**Town of Rotterdam
Planning Commission
July 19, 2022**

DPW Comments
July 19, 2022

To: Peter Comenzo, Senior Planner – Town of Rotterdam
From: Daniel Farnan, PE, CPESC, CPSWQ
Date: July 15, 2022
Subject: Rotterdam Wellness, - TM# 47.-8-1.2 –Submittal Review - Final
Project No.: CED: 21002349G - 004

SCALE:	AS SHOWN	REVISIONS:	OFFICE FACILITY TRADITIONAL BUILDERS LTD.
DATE:	10/10/90	△	
DRAWN:	SLD	△	DUANESEBURG ROAD SCHEENECTADY, NEW YORK
SHEETS:		△	FLOOR PLANS
	A1	△

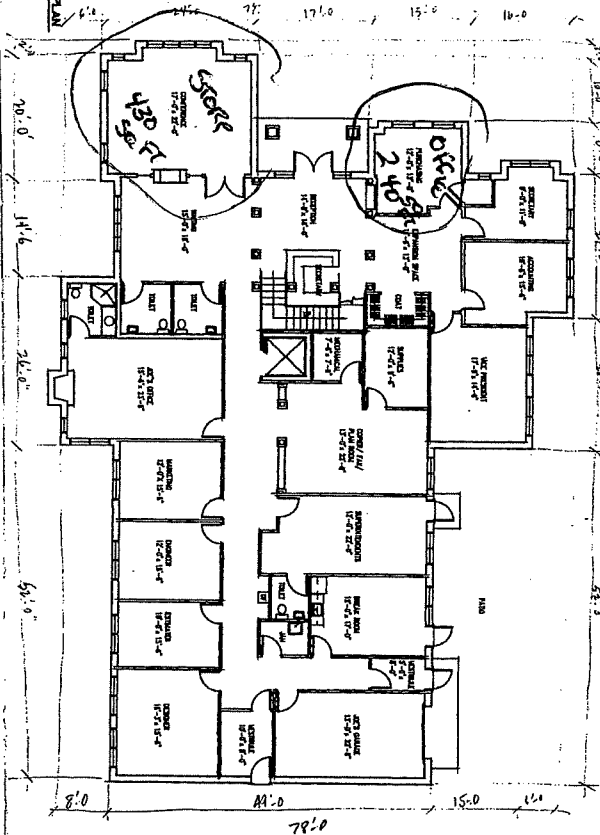
REQUEST: STORE FRONT 420 SQ FT OFFICE 260 SQ FT
